## PIC32MZ Graphics (DA) Family Silicon Errata and Data Sheet Clarification

The PIC32MZ Graphics (DA) family of devices that you have received conform functionally to the current Device Data Sheet (DS60001361H), except for the anomalies described in this document.

## Data Sheet Clarifications

The following typographic corrections and clarifications are to be noted for the latest revision of the device data sheet (DS60001361H).

FIGURE 1: Posc CRYSTAL CIRCUIT

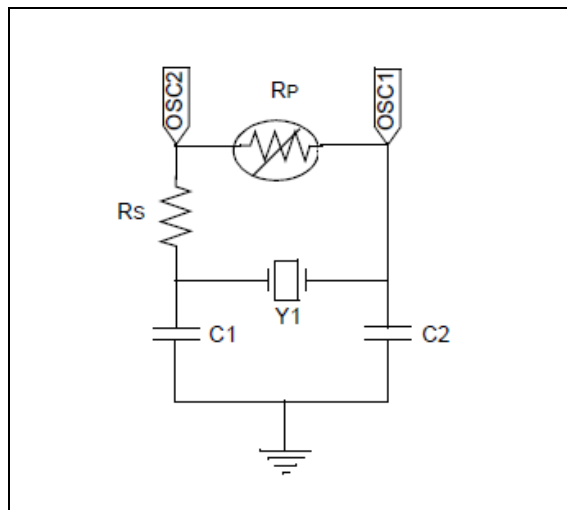
The POSC has been tested in a normal power-up sequence and supports specific crystal operation.

The Primary Oscillator (Posc) has been characterized to operate at 8 MHz and 12 MHz when the circuit shown in Figure 1 is implemented, and the operating conditions listed in Table 3 are met.

Crystal Frequency (See Note 1)	Series Resistor Rs	Posc Gain Setting POSCGAIN<1:0> (DEVCFG0<20:19>)	Posc Boost Setting POSCBOOST (DEVCFG0<21>)
8 MHz	2 kΩ	'0b00 (GAIN_0)	'0b1
12 MHz	1 kΩ	'0b00 (GAIN_0)	'0b1

**Note 1:** Using any other crystal frequency will require special component selection and characterization.

**2:** A parallel register (Rp) should not be used to increase the gain of the Posc.

FIGURE 2: EXTERNAL RESET CIRCUIT

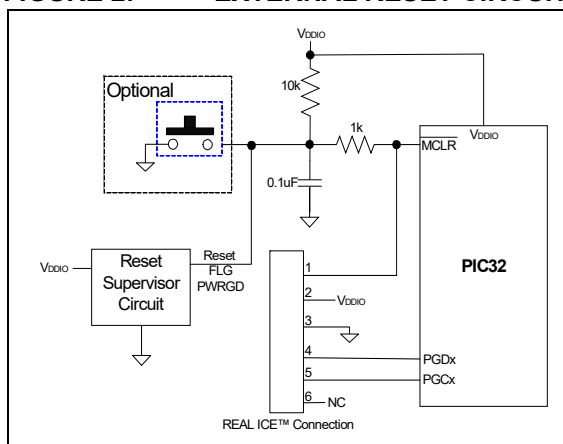
A system Reset is not generated on a BOR event ( $V_{PORIO} < V_{DDIO} < V_{BORIO}$ ). This will stop system clocks with all the I/O pin functions frozen in the present state until either  $V_{DDIO}$  falls to  $V_{PORIO}$  or  $V_{DDIO} > V_{BORIO}$ .

Reset device using a  $\overline{MCLR}$  pin through an external reset supervisor/monitor is shown in Figure 2. Set the SMCLR (DEVCFG2<15>) configuration bit to '0', which makes the  $\overline{MCLR}$  to act as a POR Reset instead of a normal system reset.

- Minimum Reset trip voltage of the external supervisor should be  $V_{BORIO}(\text{Max}) + 0.5V$ .
- The external reset supervisor/LDO output going to  $\overline{MCLR}$  should have an open drain output to not interfere with the MPLAB programming/debug tools.

When this work around is implemented, the minimum  $V_{DDIO}$  operating voltage of the application needs to be above the reset supervisor maximum trip voltage + 0.2V, where 0.2V compensates for variation in the external reset supervisor voltage.
